TO: Hannah Hippely
FROM: Charles M. Buck, P.E., PTOE
DATE: February 13, 2020
SUBJECT: Review of Site Plan
Nine Mile Corner
SP-001117-2019
FHU # 95-190

RE: NINE MILE CORNER – LOWE’S DRAINAGE REVIEW

To: Hannah Hippley
From: David Pasic, P.E., Civil Engineer
Date: February 19, 2020
Subject: **Nine Mile Commerical Site Plan**
CC: Joe Smith, Wendi Palmer, Chad Schroeder, Tyler Burhenn

NINE MILE CORNER - SITE PLAN CONSTRUCTION DOCUMENTS

CRITERIA	11.21.19
ISSUE DATE:	
PERMIT SET	
ISSUE DATE:	
CONSTRUCTION SET	
ISSUE DATE:	
DRAWING NUMBER:	C1.0

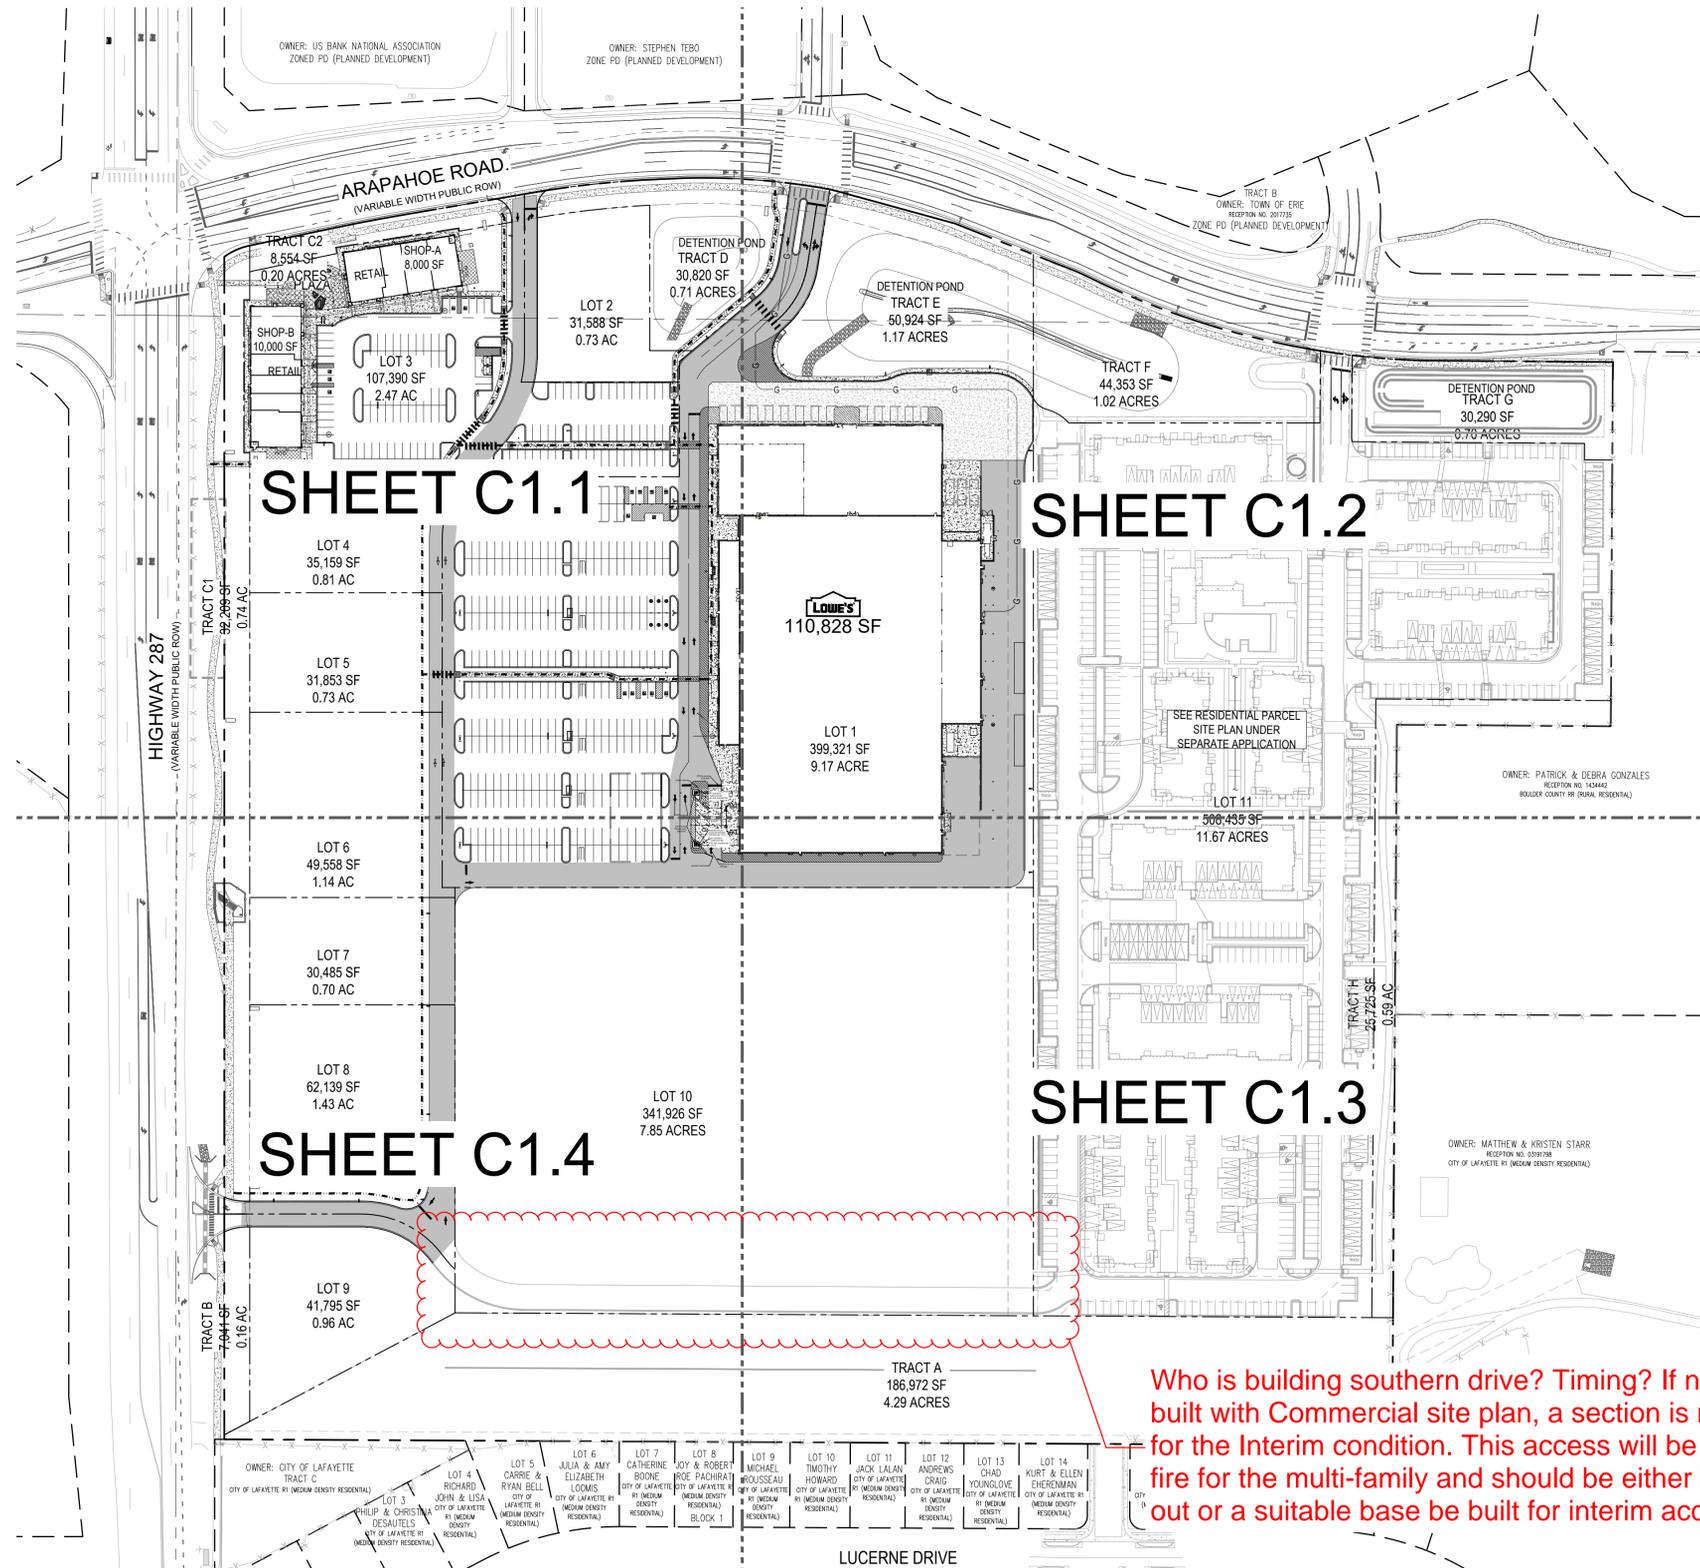
Who is building southern drive? Timing? If not being built with Commercial site plan, a section is needed for the Interim condition. This access will be used by fire for the multi-family and should be either be built out or a suitable base be built for interim access.

CRITERIA	11.21.19
ISSUE DATE:	
PERMIT SET	
ISSUE DATE:	
CONSTRUCTION SET	
ISSUE DATE:	
DRAWING NUMBER:	C2.0

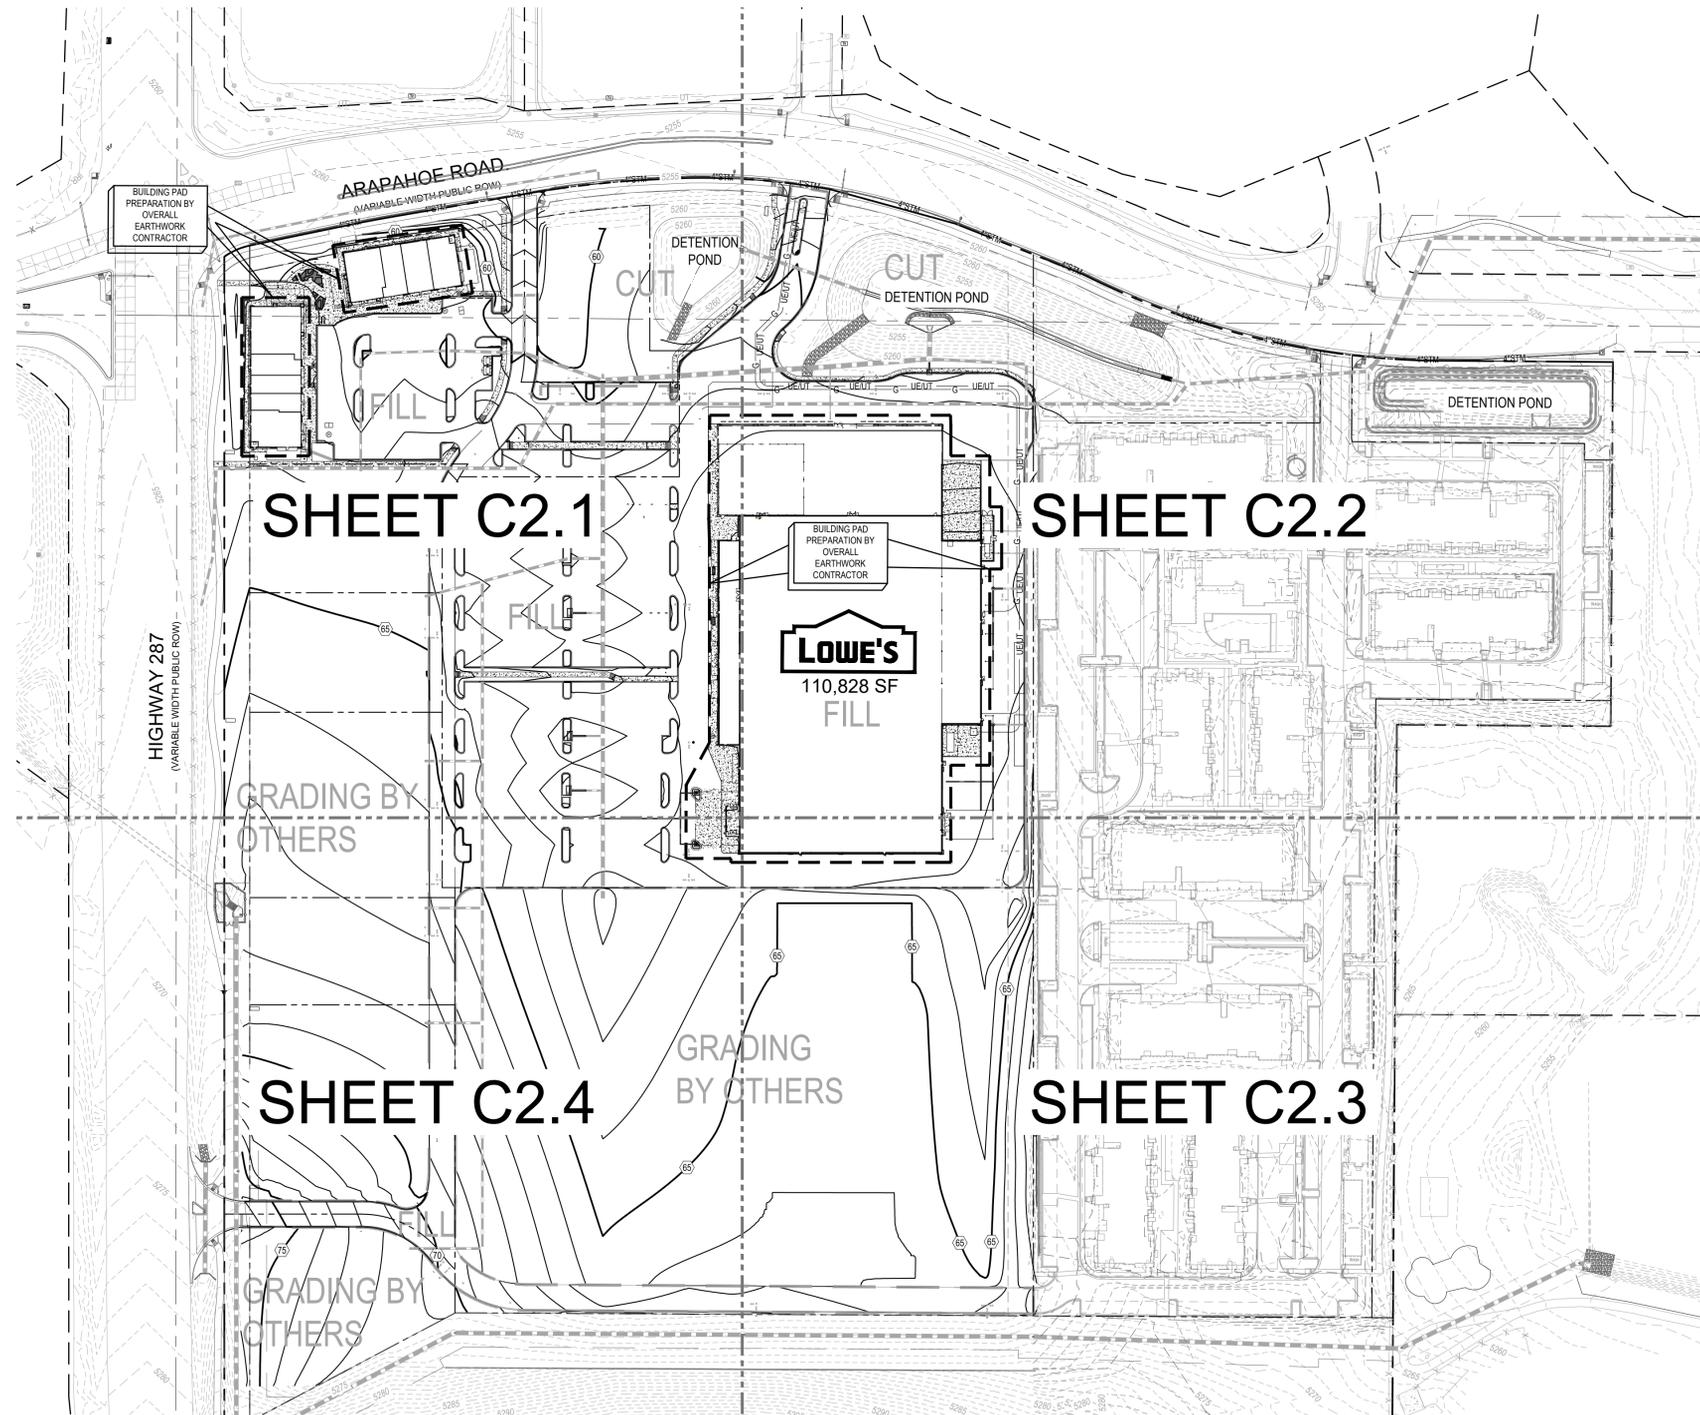
Show Lot corner elevations for each pad site (Typ)

Correction. Sheet C2.0 of the Nine Mile Corner – Site Plan Construction Documents (Galloway/Evergreen, November 21, 2019), refers to CTL's 2/17/2017 geotechnical report, which is for the residential, not commercial area. CTL's 2/24/2017 report and any subsequent geotechnical reports should be referenced in the plans.

CRITERIA	11.21.19
ISSUE DATE:	
PERMIT SET	
ISSUE DATE:	
CONSTRUCTION SET	
ISSUE DATE:	
DRAWING NUMBER:	C2.3

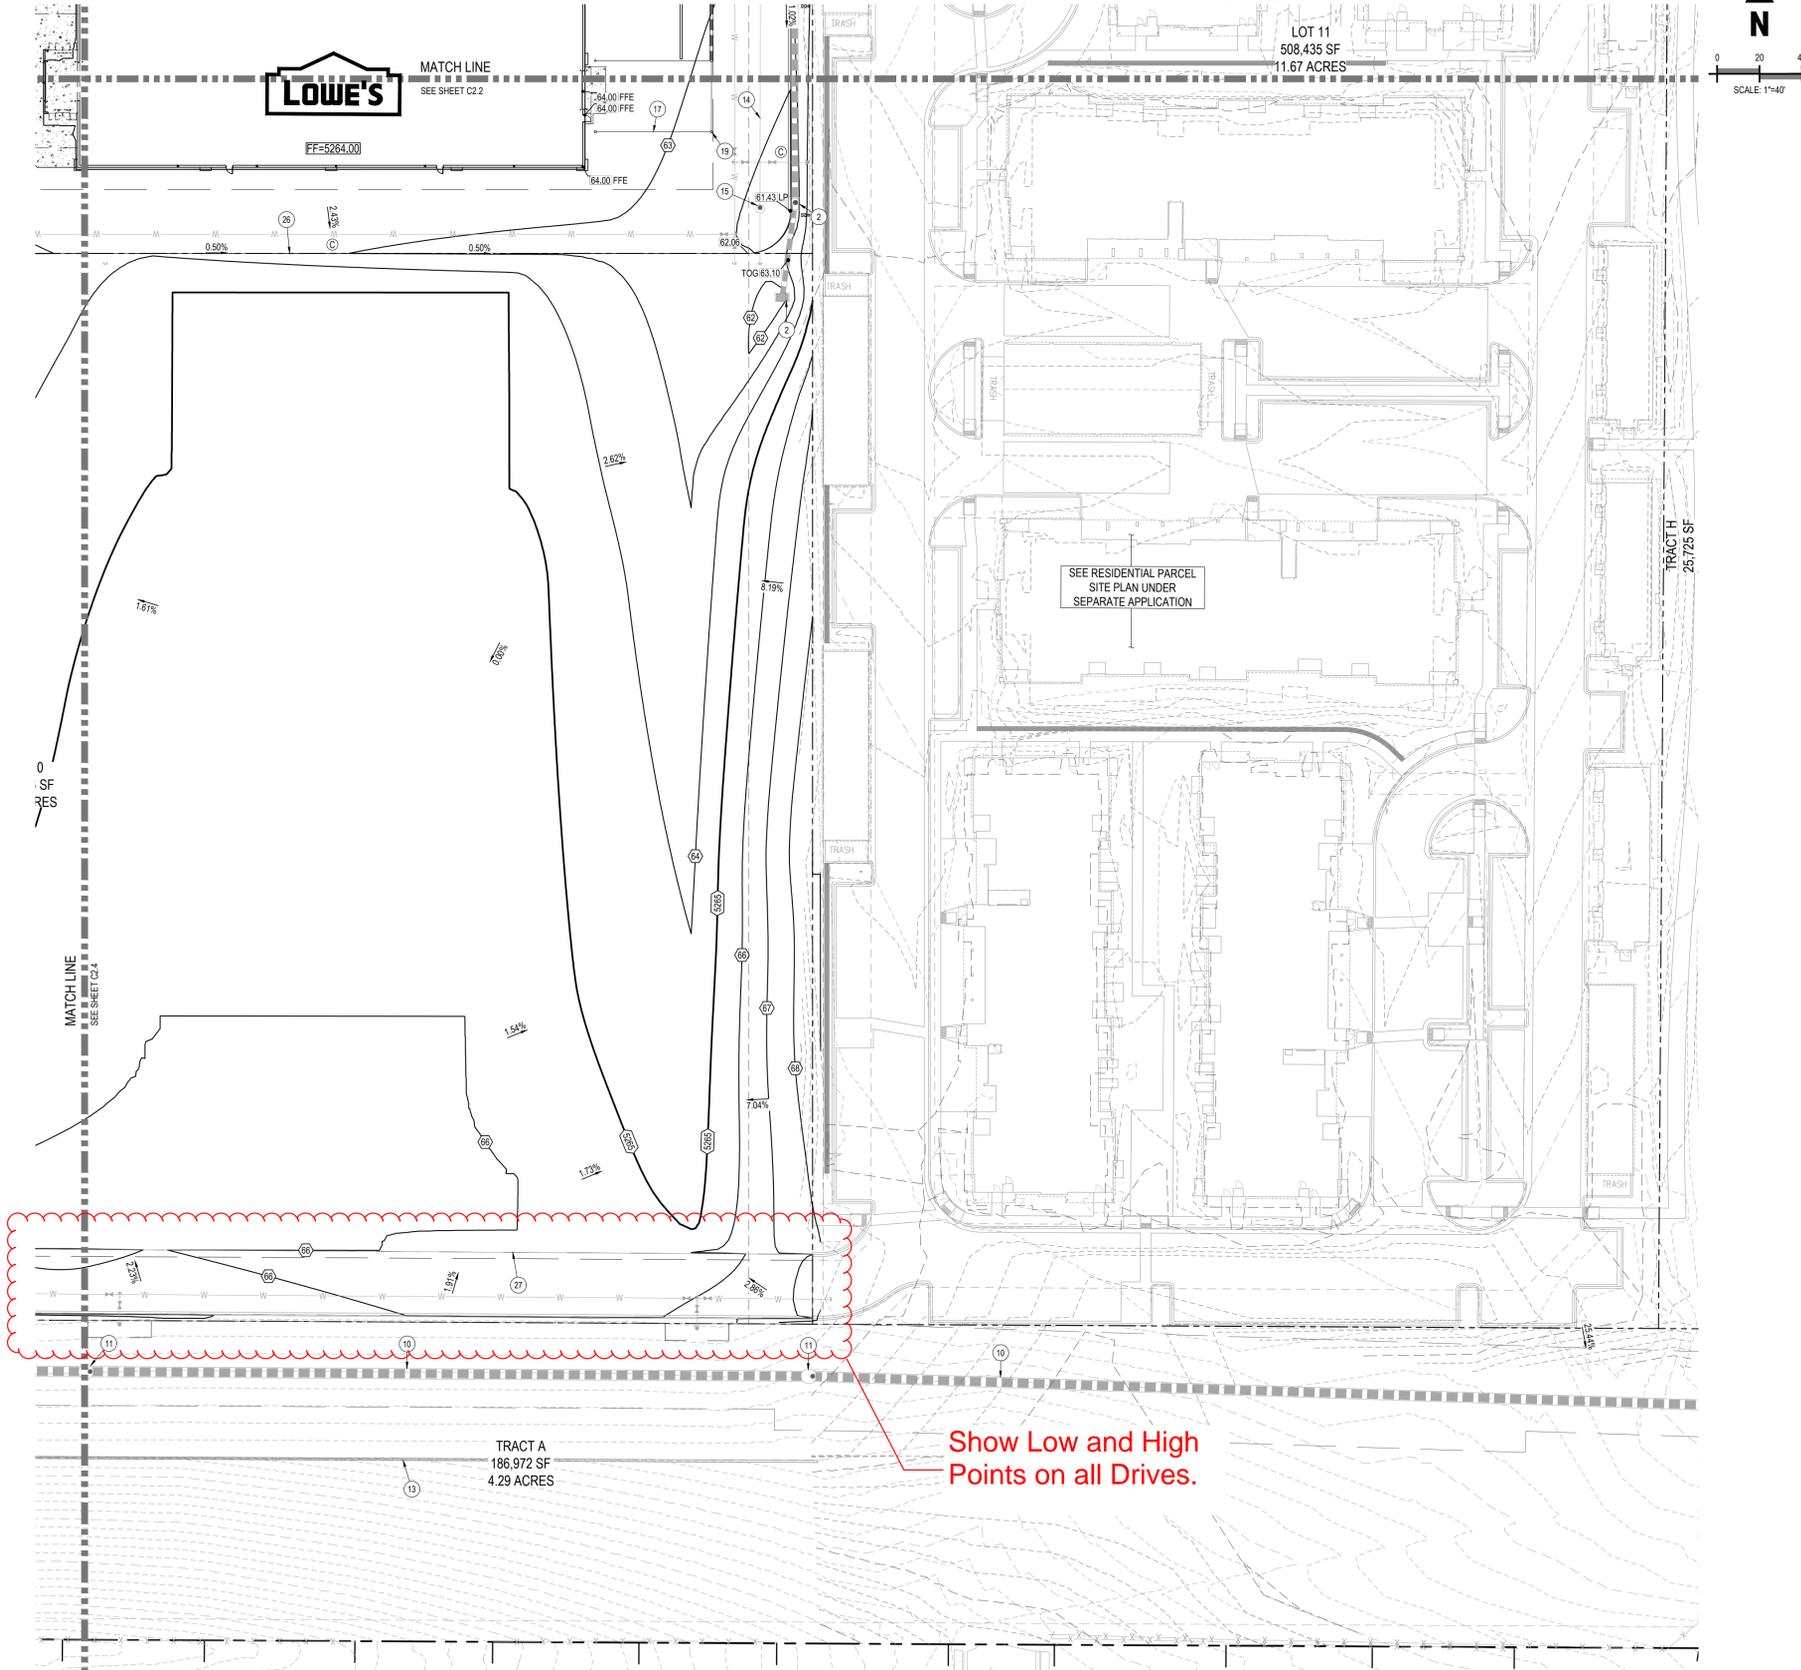
Show Low and High Points on all Drives.

4. Sheet C2.3

4. Sheet C2.3
 - a. Type D Inlet at Sta 106+60 shown on the Minor Subdivision Plans should be moved to meet low point of swale shown on Lot 10. The current placement will not allow for any real drainage capture.

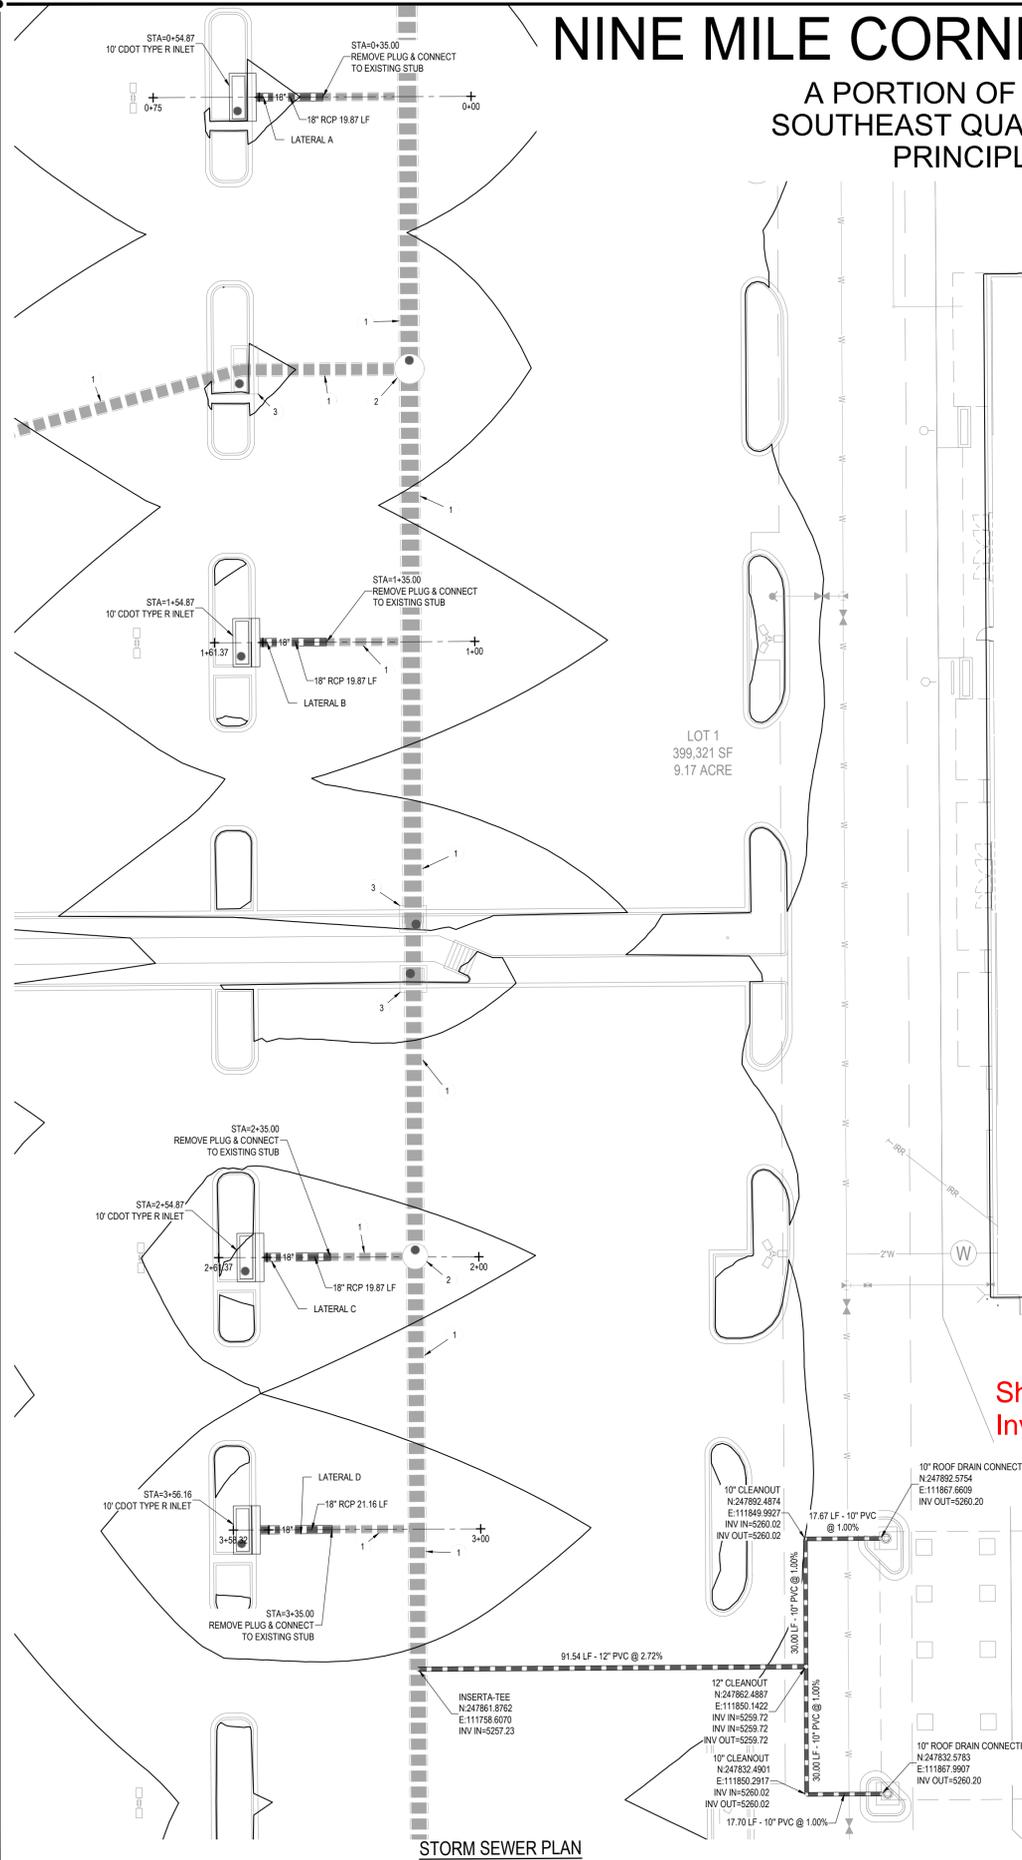
Show Vicinity Map.
 Consistent labeling
 between MS and SP
 for laterals.
